| 8802-3/802.3 REVISION REQUEST 1221 |

DATE: 8th of March, 2010  
NAME: Marek Hajduczenia  
COMPANY/AFFILIATION: ZTE Corporation  
E-MAIL: marek.hajduczenia@zte.com.cn

REQUESTED REVISION:  
STANDARD: IEEE 802.3av-2009  
CLAUSE NUMBER: 77.2.2.7; 77.3.5.6  
CLAUSE TITLE: State diagrams; State diagrams

**Figure 77–29—Gate Processing ONU Programming state diagram**

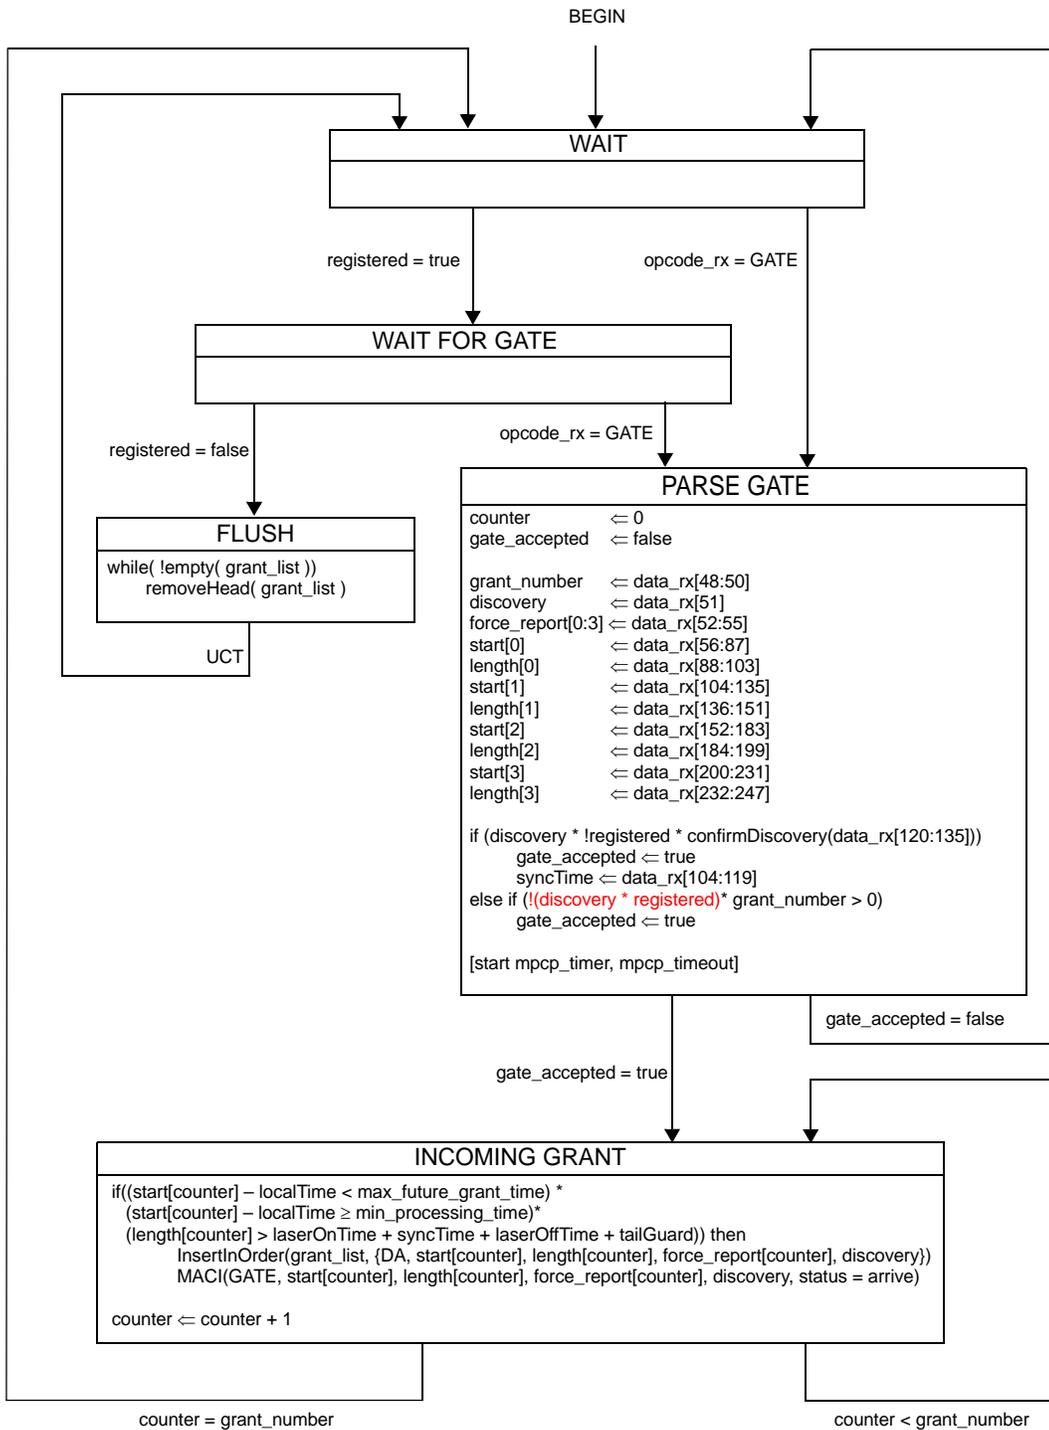
[2] Modify Figure 77-29 as presented in file "Attachment 1.pdf" - changes are marked in red.

(3) OLT allocates a slot for this ONU, which will be processed according to Figure 77-29. This allocation will allow the ONU send a REGISTER\_ACK MPCPDU (with NACK flag set in this case). GATE MPCPDU with this slot reaches an ONU and is dropped on condition 'else if (!discovery \*'

registered \* grant\_number > 0)' and the first condition 'if (discovery \*  
!registered \* confirmDiscovery(data\_rx[120:135]))' is also false since  
register flag is false, discovery is also false. Effectively, the  
transmitted GATE MPCPDU will be dropped.

[1] Add a missing variable to 77.3.5.2 into a correct location (sorted alphabetically)

gate\_accepted

TYPE: Boolean

This variable indicates whether the received GATE MPCPDU will be accepted by the Gate Processing ONU state diagram as shown in Figure 77-29.

DEFAULT: false

Figure 77-30—Gate Processing ONU Activation state diagram

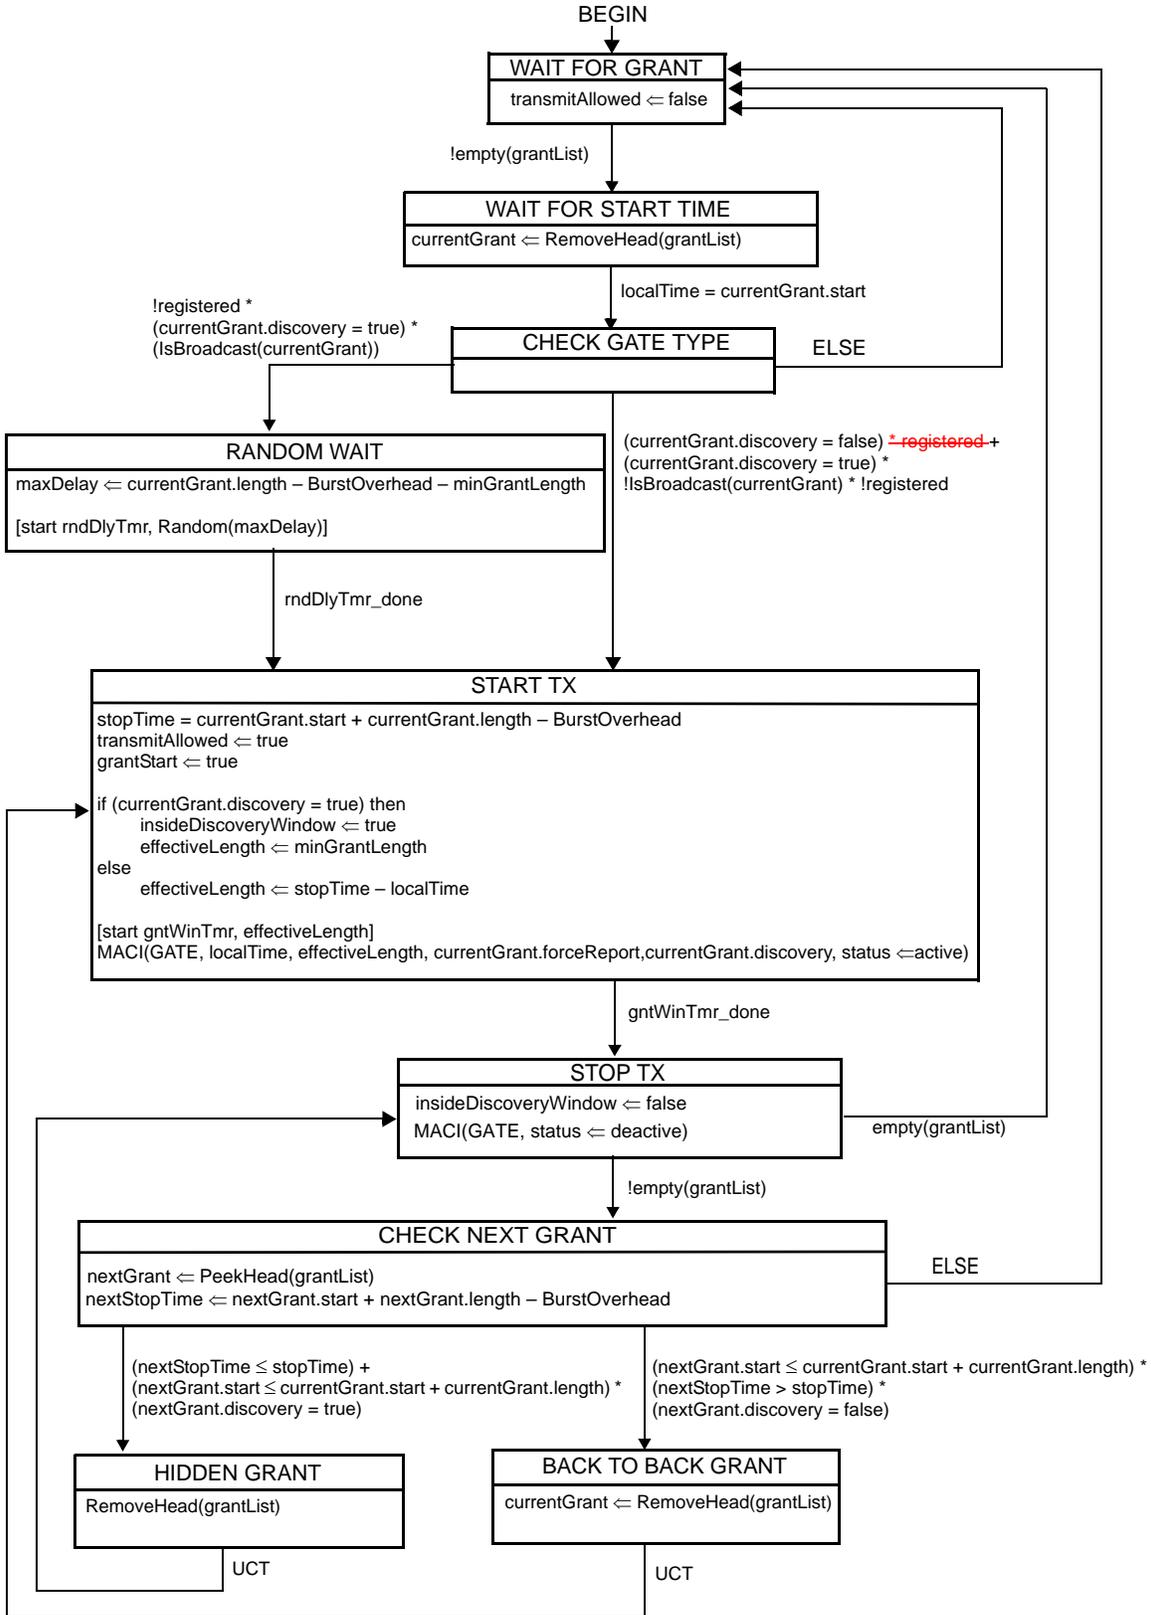
[3] Modify Figure 77-30 as presented in file "Attachment 1.pdf" - changes are marked in red.

(4) additionally, even if the granted slot is inserted into the queue  
according to the state diagram in Figure 77-29 with the proposed changes,  
it will be dropped according to the state diagram in Figure 77-30. If the  
ONU MAC Client denied registration and register variable is false, all  
the transmission slots, received and stored in the slot queue according  
to the state diagram in updated Figure 77-29 (as proposed in this  
maintenance request), will be dropped in the state diagram in Figure 77-  
30, since conditions (a) and (b) at the CHECK GATE TYPE state evaluate to  
false:

- (a) !registered \* (currentGrant.discovery = true) \*  
(IsBroadcast(currentGrant))
- (b) (currentGrant.discovery = false) \* registered +  
(currentGrant.discovery = true) \* !IsBroadcast(currentGrant) \*  
!registered

This means that ELSE branch is taken and grant are effectively dropped.
